Independent Peer Review of a Microclimate Assessment for Planning Application 200188 at 53-55 Vasten Road, Reading, RG1 8BU

BRE have been appointed by Reading Borough Council (RBC) to undertake an independent peer review of RWDI report #1901994 Pedestrian Level Wind Comfort Assessment of 55 Vasten Road, Reading, dated 29th January 2020.

Figure 3 51 Vastern Road approved floor plans, from drawing PDM-06 Rev C by The Keen Partnership.

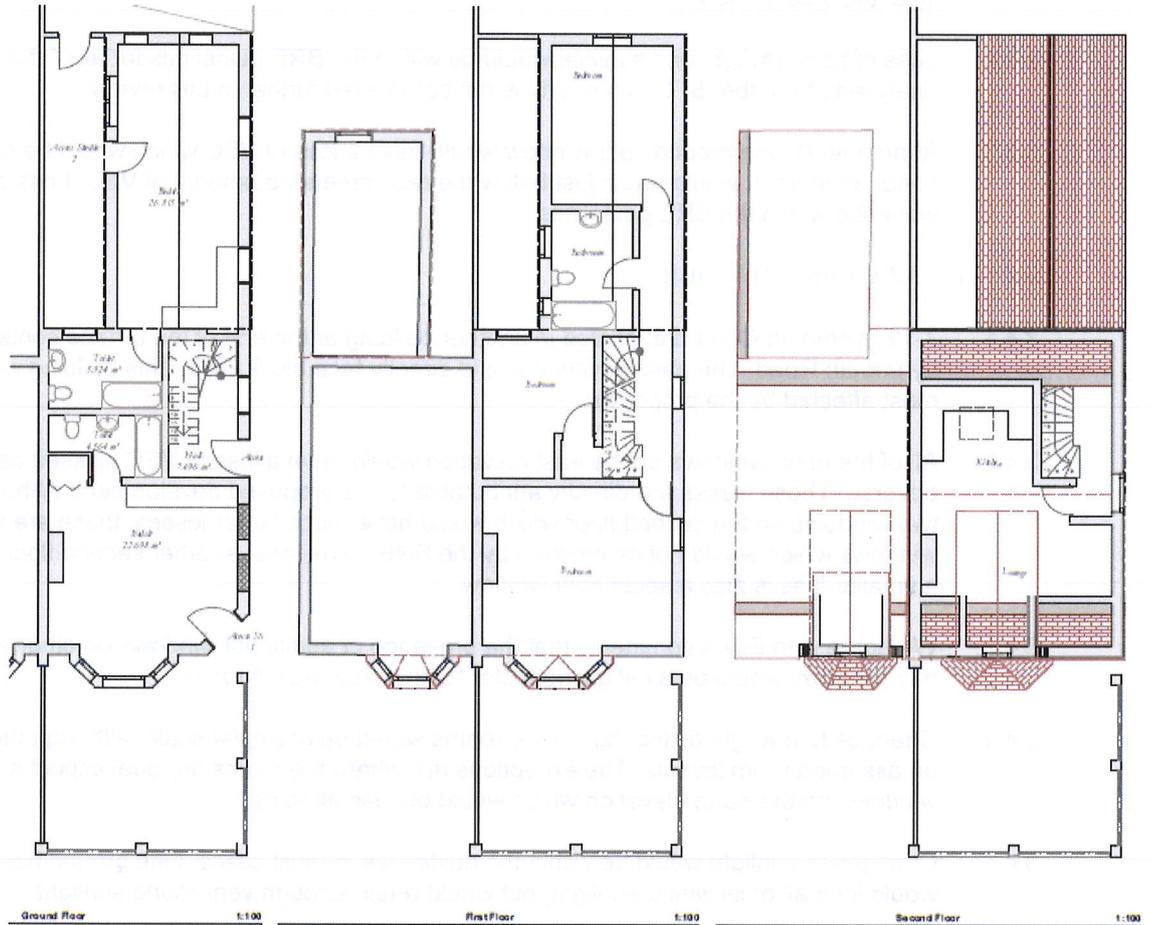
- 3.5.2 Valuation Office Agency records indicate that there is currently a flat on the first floor. At the time of writing there was no record of a ground floor flat and online streetview imagery shows a café on the ground floor. The recent planning history for the property includes some plans: a permitted development application reference 190692 for conversion of the upper floors to two flats and a planning application reference 191165 for conversion of the ground floor to two bedsits. The proposed room layouts for the latter are shown in Figure 3 below. The room layouts for the upper floors differ from those in the earlier permitted development application.

3.5.3 These room layouts, and the layouts in the existing plan submitted in the same application, suggest that the affected windows on the ground and first floors are either secondary windows with the main windows located on other elevations, or light stairwells. It therefore appears likely that none of the affected windows are covered by the BRE guidelines.

Figure 4 Block A first floor, ADF failure marked

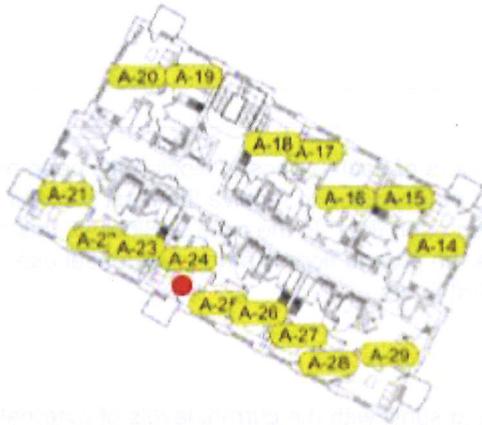
- 4.2.2 Living room A-24 on the first floor, see Figure 4 below, would have an ADF of 1.4%, just below the recommended minimum for living rooms. This is a large room facing south west with a balcony located above the window. This would normally be less of an issue as it is not unusual for a few rooms in a development to receive less daylight, the ADF would be only just below the guidelines and the balcony design gives the compensatory benefit of private amenity space. However, the concern is that at the moment the area opposite, Vastern retail park, is low rise, so the only limit on the daylight received by this room is the design of the development itself. This is anticipated to change. The design and access statement notes that there is an emerging development on the Vastern retail park site on the other side of Vastern Road. The developers of that site will also wish to make best use of their site and the levels of obstruction can therefore be expected to increase significantly in the future. If a room cannot receive enough daylight when it has very little external obstruction, it is likely to become significantly worse in the future. Windows with balconies above them can be expected to lose a larger proportion of their daylight if obstruction levels opposite them increase. This room is therefore vulnerable to a substantial future loss of light with its present design.

- 4.2.3 The ground floor room below, which does not have a balcony rail in front of it, would receive just enough daylight with current levels of obstruction. The equivalent rooms on the upper floors would be expected to have similar results to the first floor. Whether they would be similarly affected by a development on the Vastern retail park site would depend on the height and proximity of the proposed buildings. Subject to other factors involved in site design, these rooms would benefit from some additional glazing which is not underneath a balcony to protect them from a disproportionate loss of daylight when Vastern retail park is redeveloped.

Figure 6 Block BC ground floor, ADF failures marked.

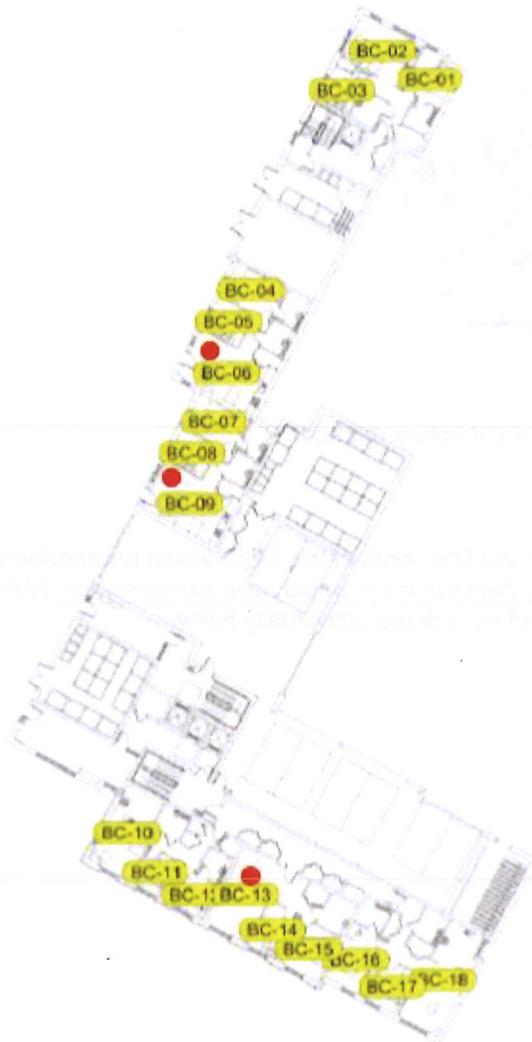
- 4.3.2 Living room BC-06 on the ground floor faces north west. It would have an extremely low ADF of 0.3%, where the recommended minimum for living rooms is 1.5%. This room would be very gloomy and need supplementary electric lighting almost all the time. Daylight provision to this room should be improved if at all possible. The equivalent room on the first floor would be better but would still fall well short at 1.0%. The main windows face the terrace of two storey houses on Lynmouth Road, and would therefore not be particularly obstructed externally; their poor levels of daylighting are therefore a consequence of their own design and the equivalent rooms on upper floors may well have the same issue. In particular, the ground floor room has a much narrower main window than the first floor room and has the potential for improvement subject to other site design factors. They both appear to have the potential for increased window area in their side elevation.

- 4.3.3 Living room BC-09, also on the ground floor and facing north-west, has a low ADF of 0.9%. This room is large for its window area. There appears to be some limited potential to increase window area but it is unlikely to be possible to bring this room up to a pass without loss of room area.

Figure 8 Block EFG ground floor, ADF (red) and sunlight (green) failures marked.

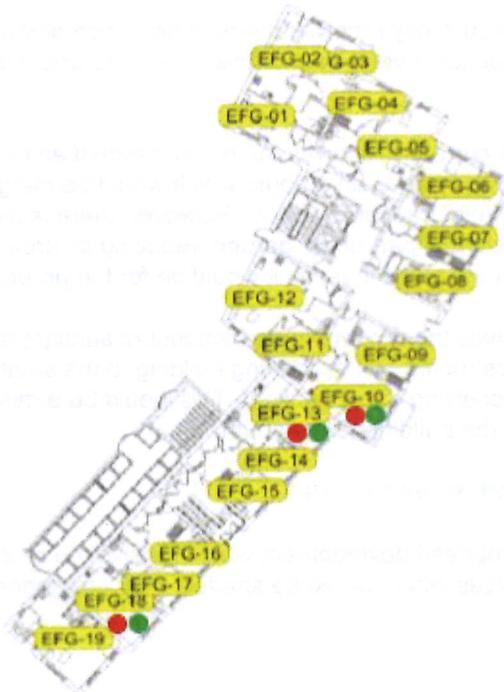
- 4.5.2 Three ground floor rooms in this block, marked in Figure 8 below, would not receive enough of either daylight or sunlight. The individual rooms are discussed below.

- 4.5.3 Living room EFG-10 is dual aspect. It has a main window facing south east which is located underneath a balcony and a secondary window facing south west. It would have an ADF of 1.4%, just below the recommended amount for living rooms. It would receive the recommended amount of year round sunlight, but would receive just below the recommended amount of winter sunlight. The sunlight would be difficult to change due to the other buildings in the development presenting an obstruction to the south and east, and year round sunlight is more important. However, subject to other site design factors, the ADF could potentially be improved by increasing the glazing area.

- 4.5.4 Living room EFG-13 faces south east. It would be extremely poorly daylit. It is a large room for the size of its window and it would have an ADF of 0.3% against a recommended minimum for living rooms of 1.5%. It would also receive almost no sunlight, 3% of annual probable sunlight hours against a recommended minimum of 25%, and 2% of winter sunlight hours against a recommended minimum of 5%. It would be a very gloomy room which would need supplementary lighting almost all of the time. On higher floors, the rooms in the same position don't have the same problem as there is another window to the rear of the room. Daylight to this room should be improved if at all possible. It would be difficult to improve the amount of sunlight it receives as sunlight is obstructed by the other blocks of the development. This makes reasonable daylight provision even more important.

- 4.5.5 Living room EFG-18 also faces south east. It would have an ADF of 0.6% against a recommended minimum of 1.5% for living rooms. The room is large for its window size. There appears to be some limited potential for increased window area, but it is probably not possible to bring the daylight up to a pass without losing floor area or making very large changes to the design of the scheme. The window would also fall substantially short of the sunlight requirement, receiving 5% of APSH against a recommended minimum of 25%. Winter sunlight would be better, and only slightly below the recommended minimum.

- 4.5.6 We disagree that the very poor results should be accepted as isolated deviations and suggest that the design should be revisited to see if their daylight and sunlight provision can be improved any further. The fact that other homes in the development would be better daylit would not provide any comfort to the people who live in the very poorly lit properties. In particular, 0.3% is an exceptionally low ADF which will provide very poor living conditions.
